DSOX3032A-01

S E R V I C E N O T E

DSOX3032A – Oscilloscope, Mixed Signal, 2 Channel,
350MHz

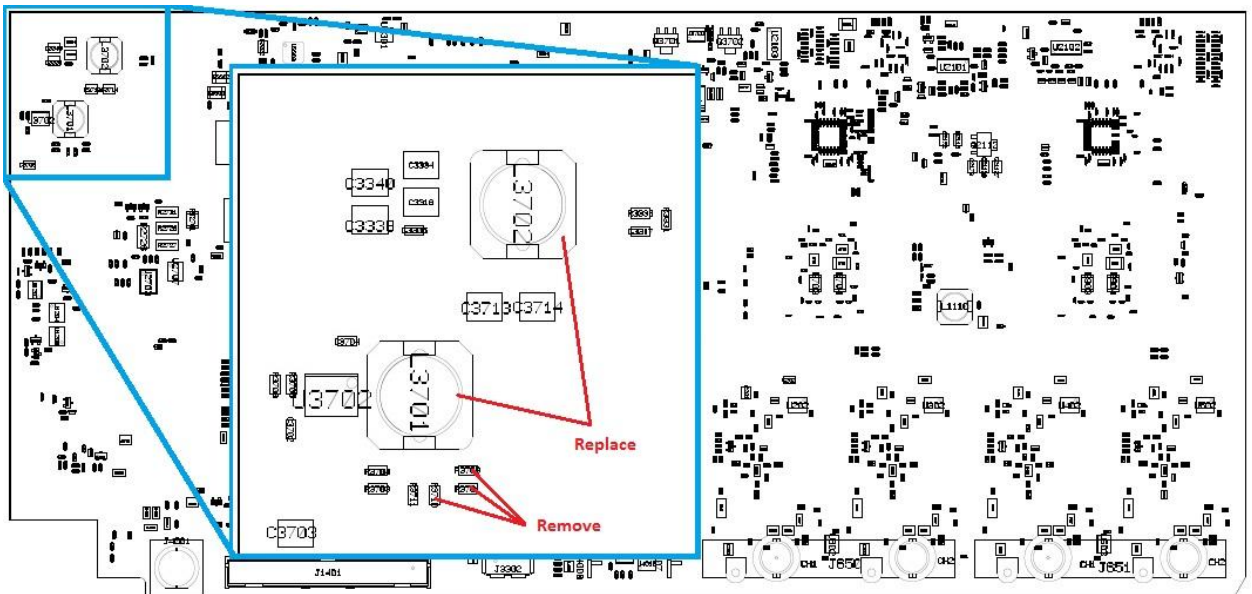
With the oscilloscope power turned on and while under normal operation, the unit emits a hissing noise.

2. As the picture indicates, remove the three resistors (0699-7209, 1 Ohm) located at R3701, R3709, and R3710. They are not to be replaced.
3. Remove as well the two inductors (9140-6474, 100uH) located at L3701 and L3702 and replace them with inductors with part number 9140-6151 (68 uH).
4. Re-assemble to the point where the unit could be powered up to verify that the hissing is indeed gone. If the hissing is not gone, please, check modifications.
5. When the hissing is gone, put oscilloscope back together.
